工程指示 / 要求簡箋 ENGINEER INSTRUCTIONS (E.I.)

| 工程指示編號: | EI- 4790D | 修改版本: | D |
| 工程編號: | J 853 | 工程名稱: | 大窩坪 (延坪道) |
| 工程項目: | T3 幕牆單元件生產 (大貨) (修訂D:修改Z字碼設計及修改分格呎吋) | 日期: | 29/07/2022 |

| 名稱 | 生邊企 | 制圖 | 付吉寧 | 2022.05.20 | 修改 | A | B |

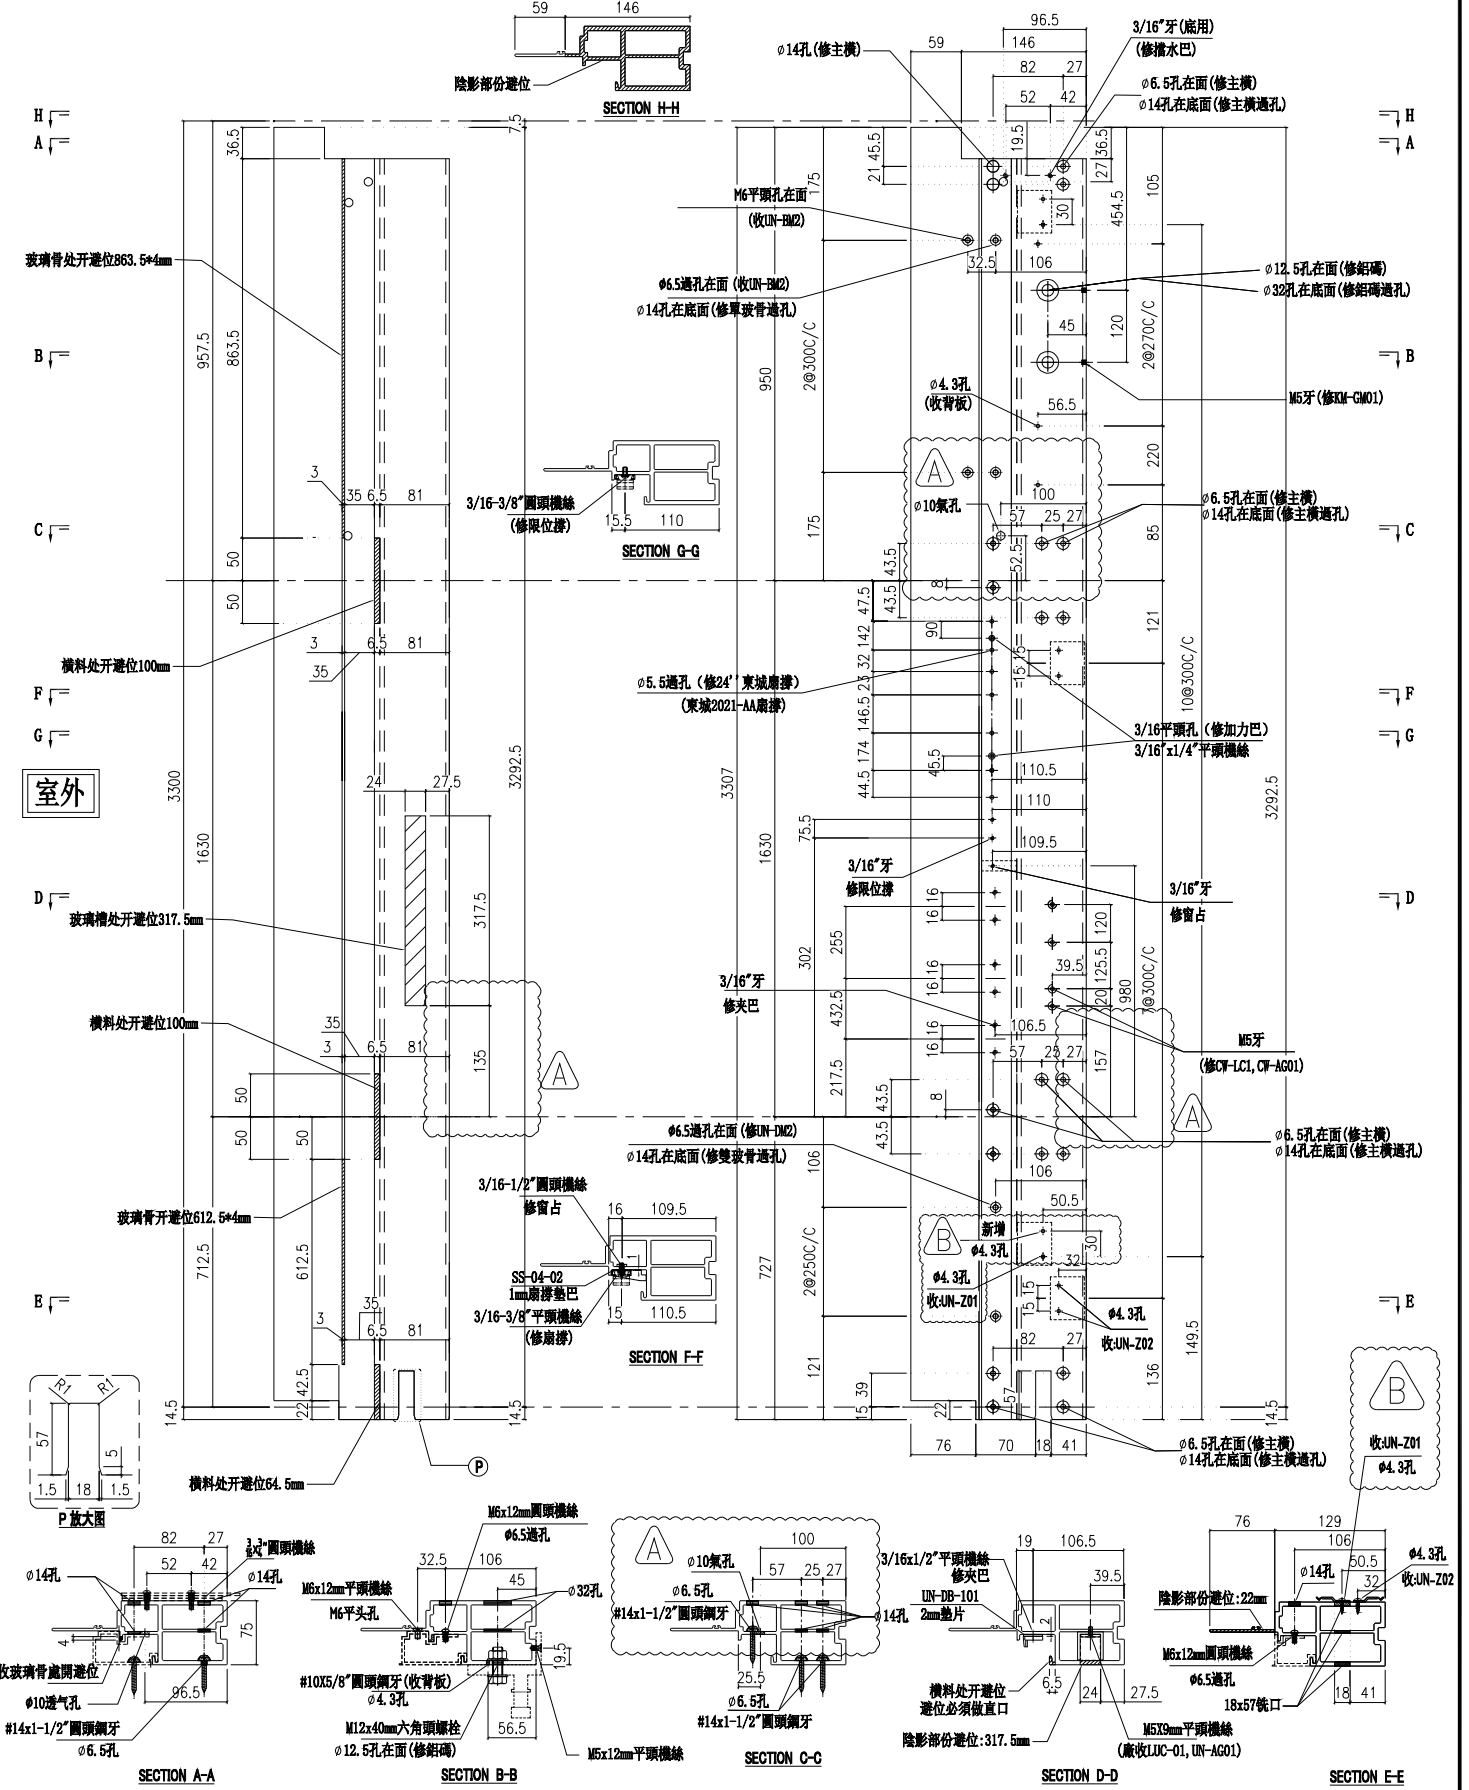
依據E14825, 修改欄河槽及孔位尺寸

依據E14878-B版更換Z字碼及新增Z字碼孔位
原Z字碼編號: UN-Z03-02改為: UN-Z01

新增 $\phi 10$ 氣孔

| 名稱 | 生邊企 | 制圖 | 付吉寧 | 2022.05.20 | 修改 | A | B |

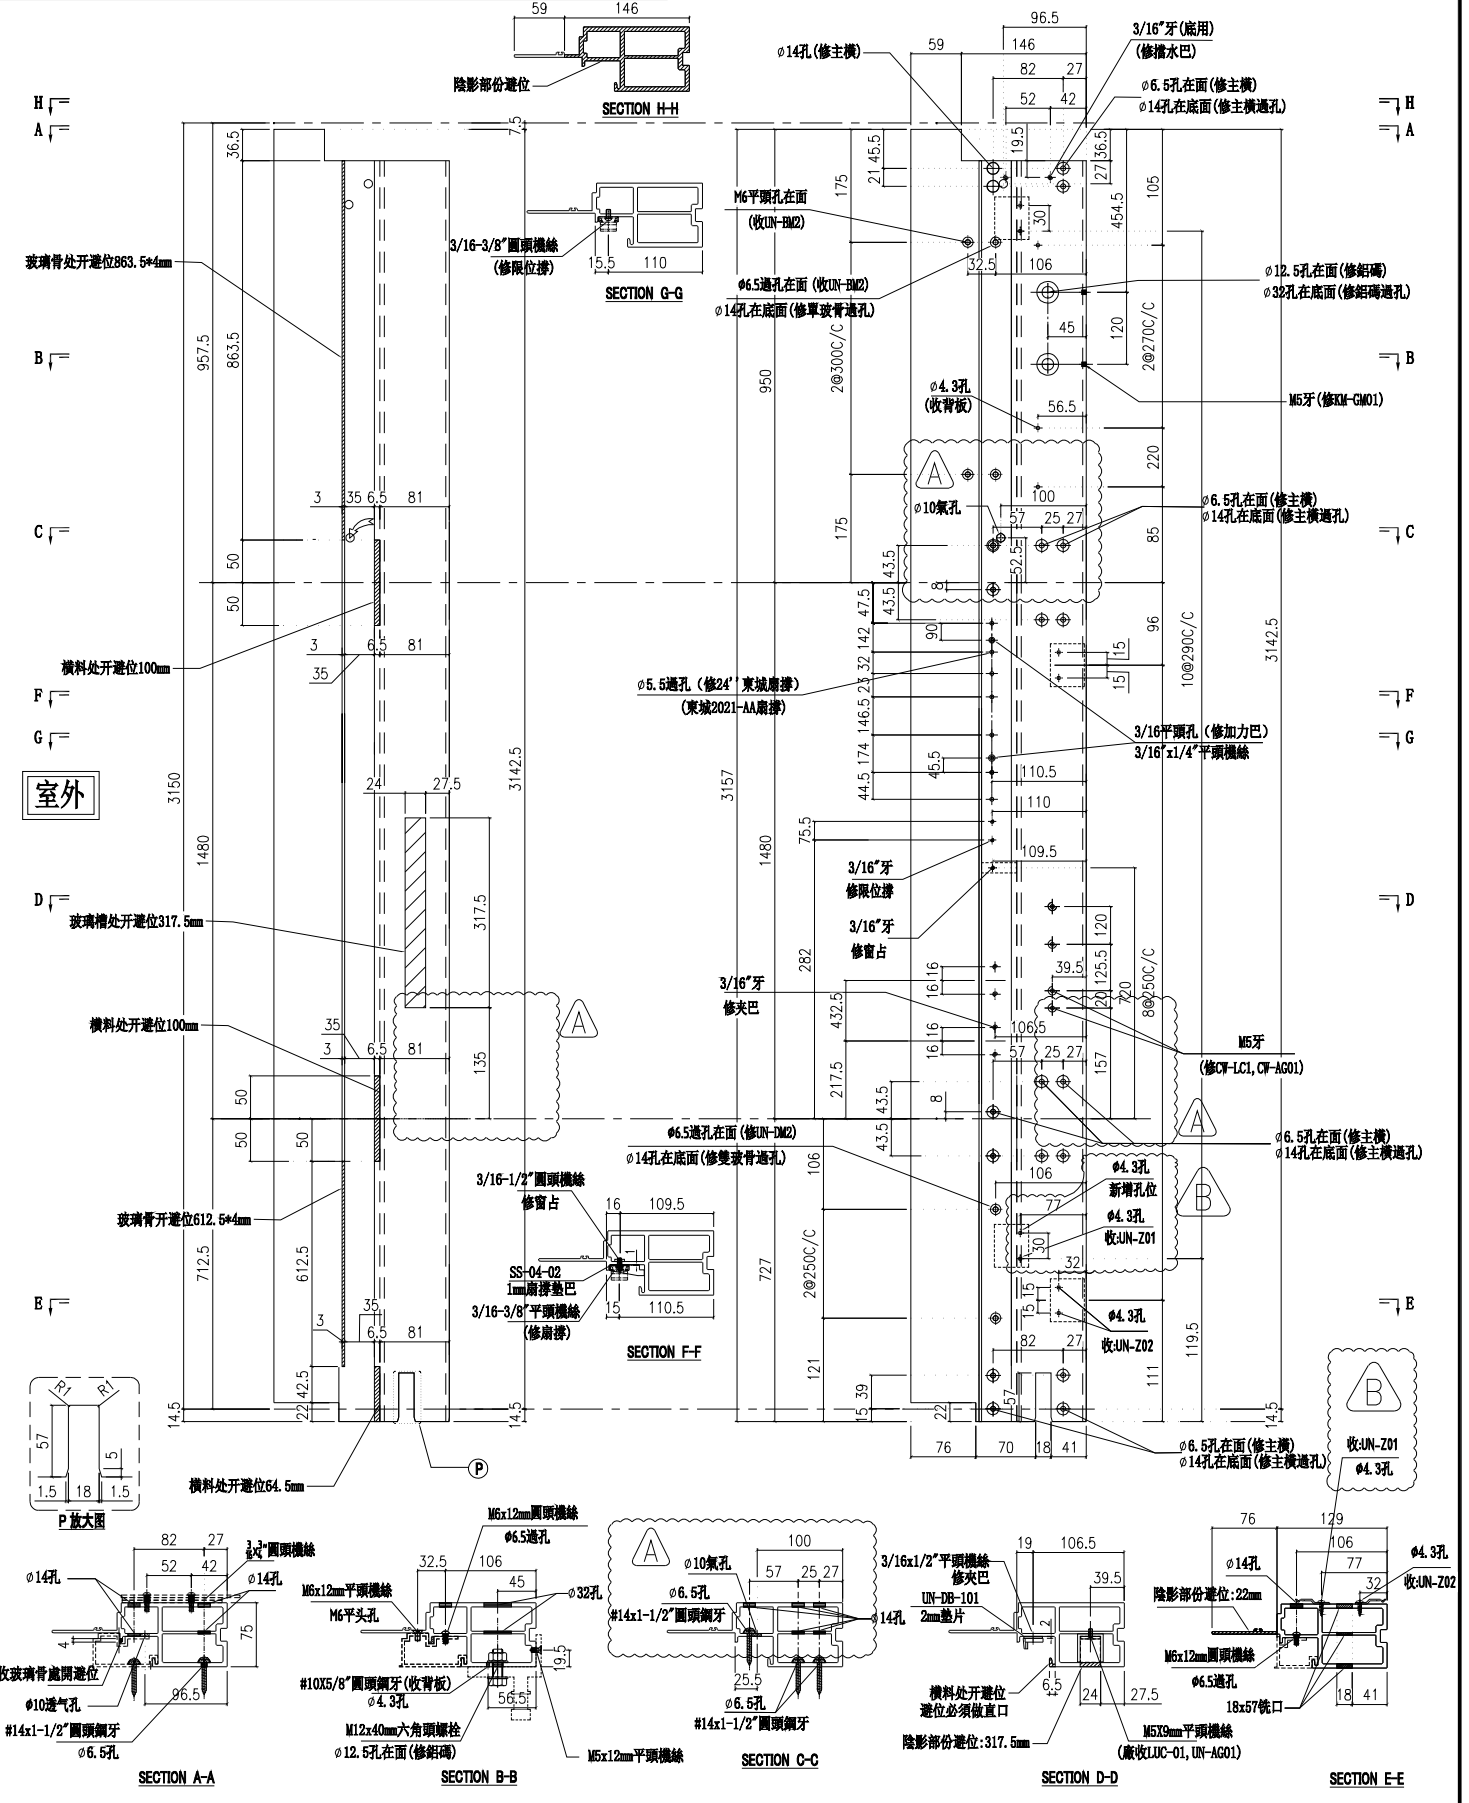
依據E14825,修改欄河槽及孔位尺寸
新增 $\phi 10$ 氣孔

依據E14878-B版更換Z字碼及新增Z字碼孔位
原Z字碼編號: UN-Z03-01改為: UN-Z01

| 名稱 | 生邊企 | 制圖 | 付吉寧 | 2022.05.20 | 修改 | A | B |

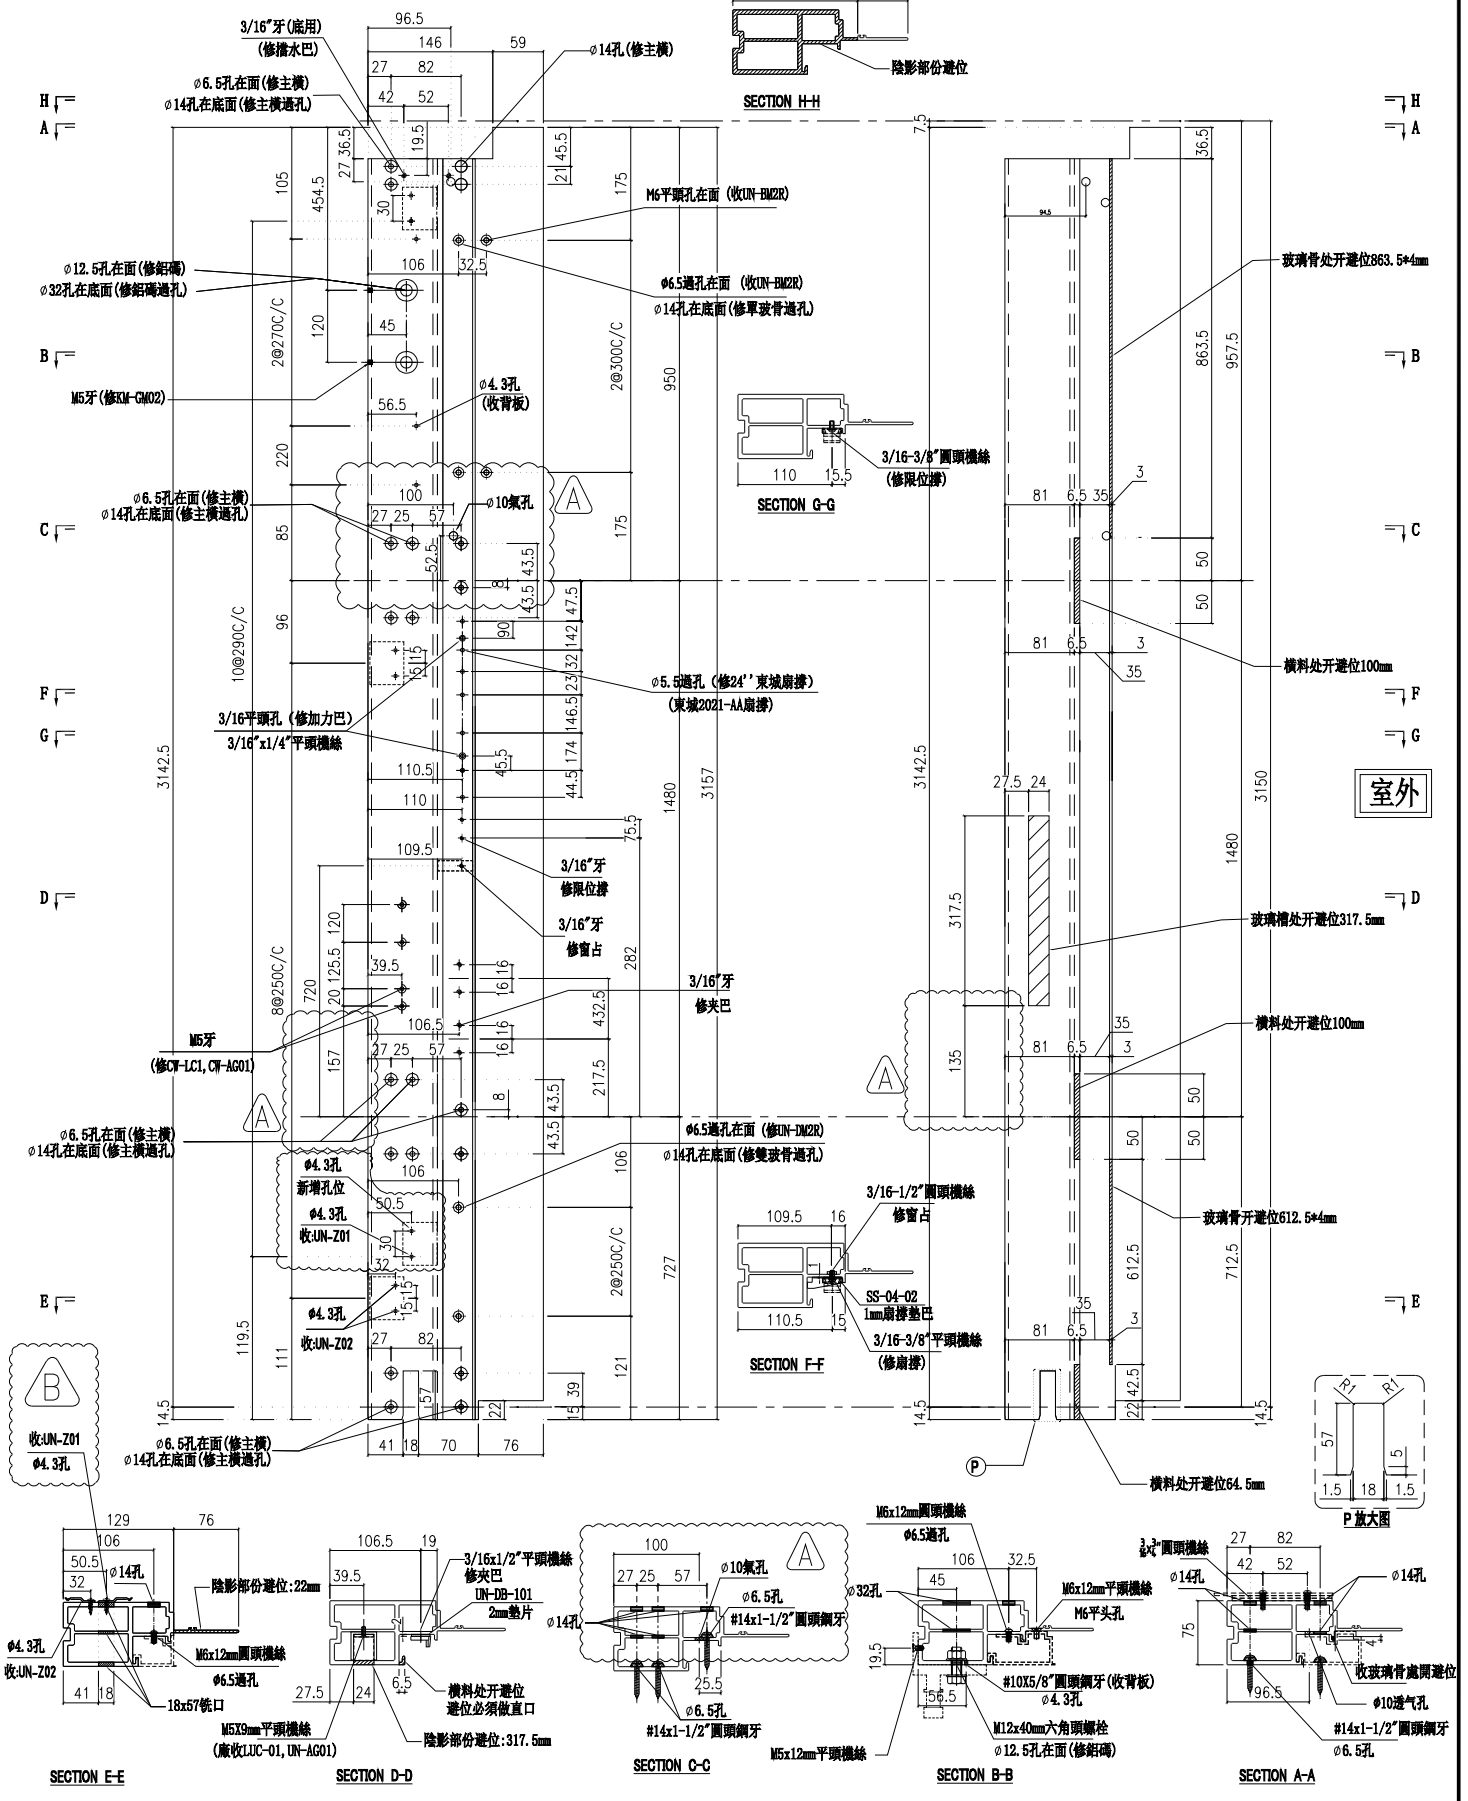
依據BI4825, 修改欄河槽及孔位尺寸

依據E14878-B版更換Z字碼及新增Z字碼孔位
原Z字碼編號: UN-Z03-01改為: UN-Z01

新增的10氣孔

| 名稱 | 生邊企 | 制圖 | 付吉寧 | 2022.05.20 | 修改 | A | B |

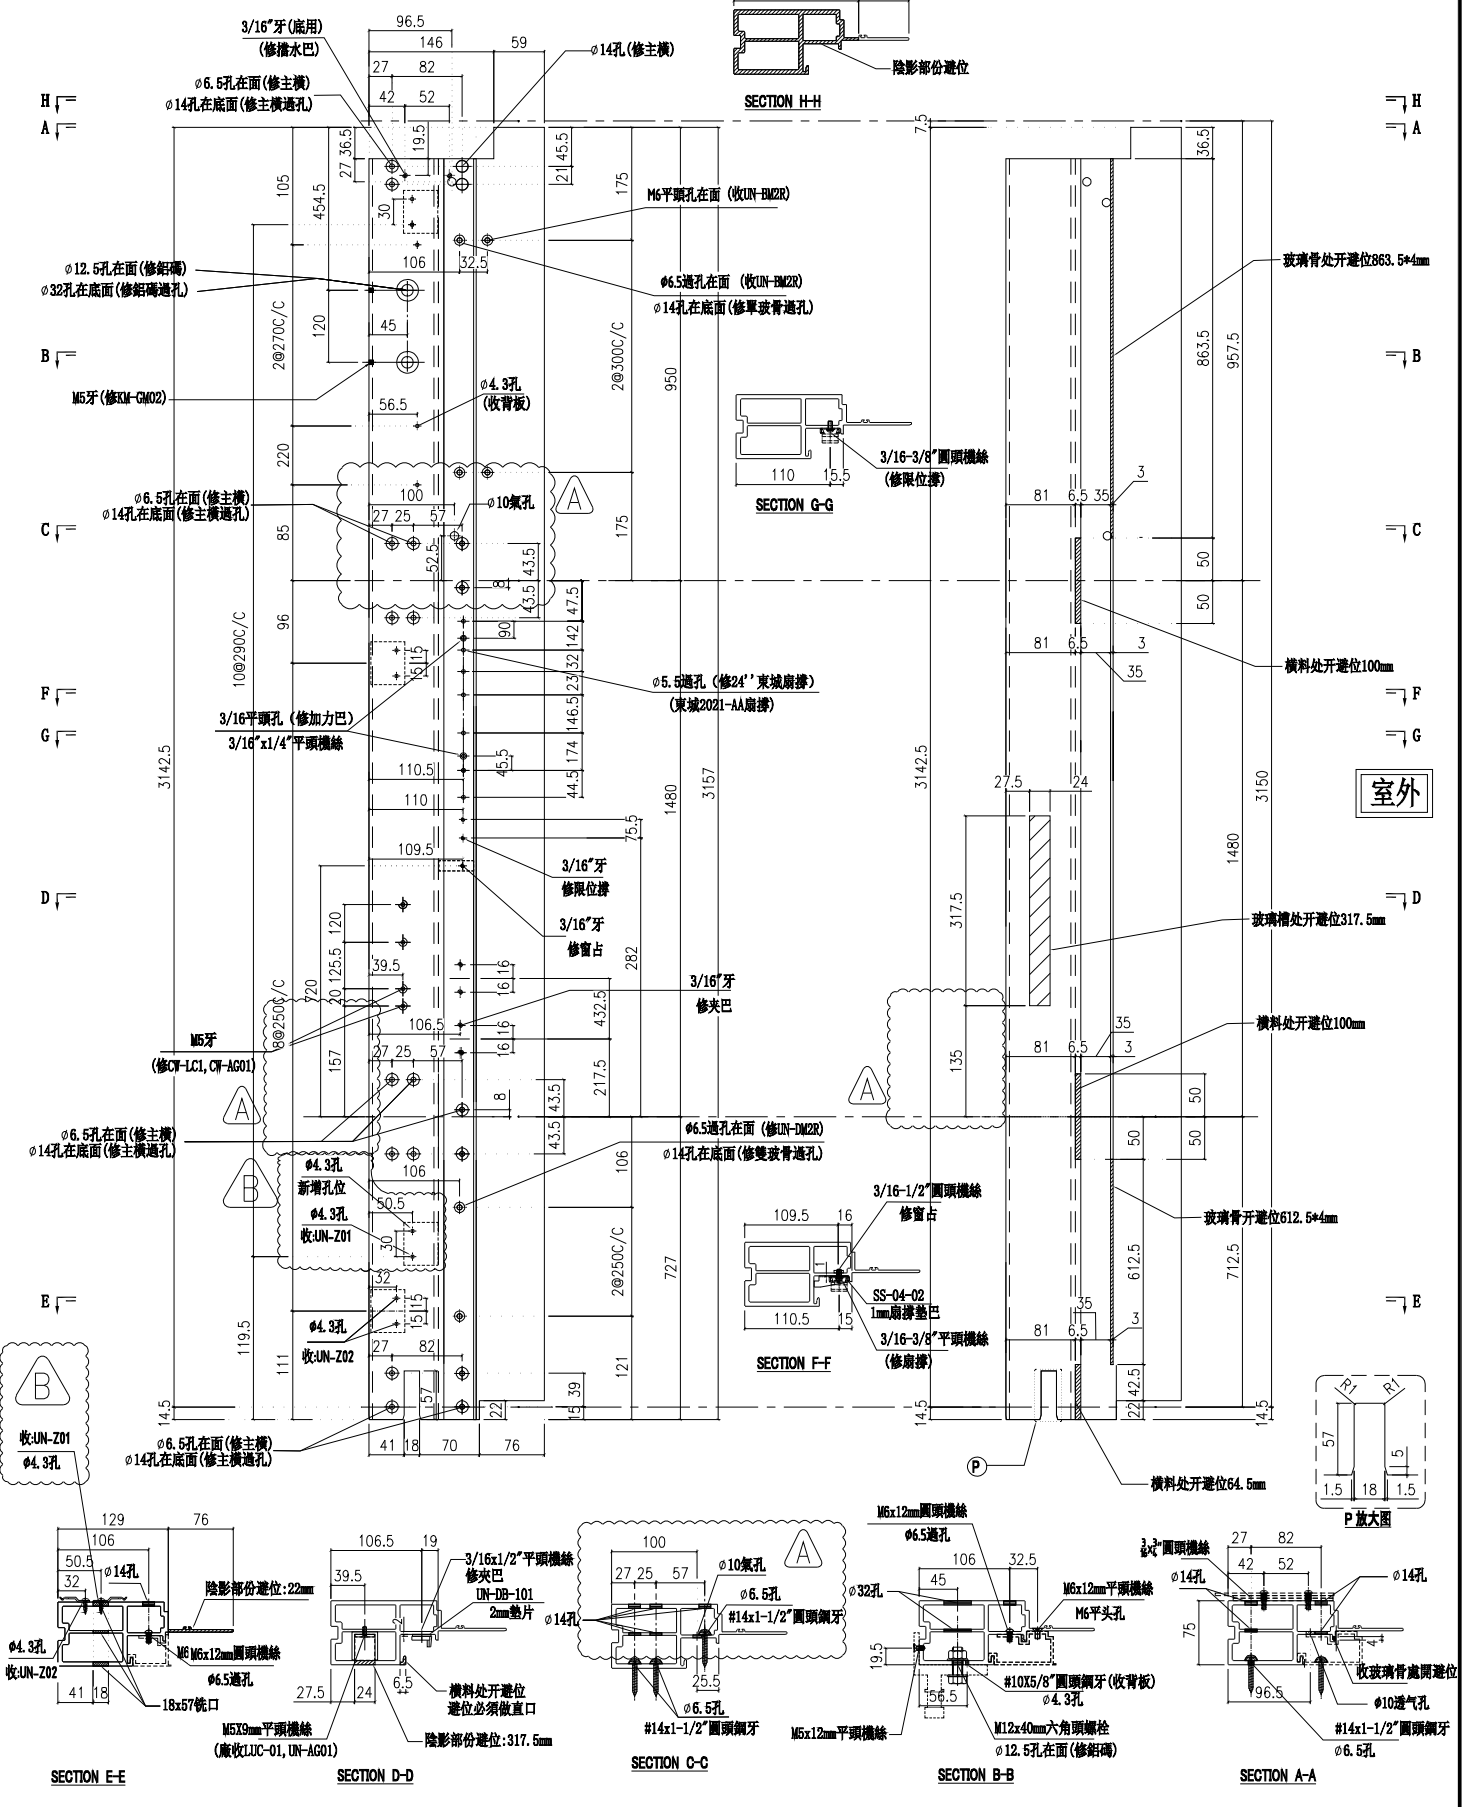
依據E14825, 修改欄河槽及孔位尺寸

新增 $\phi 10$ 氣孔

依據E14878-B版更換Z字碼及新增Z字碼孔位
原Z字碼編號: UN-Z03-01改為: UN-Z01
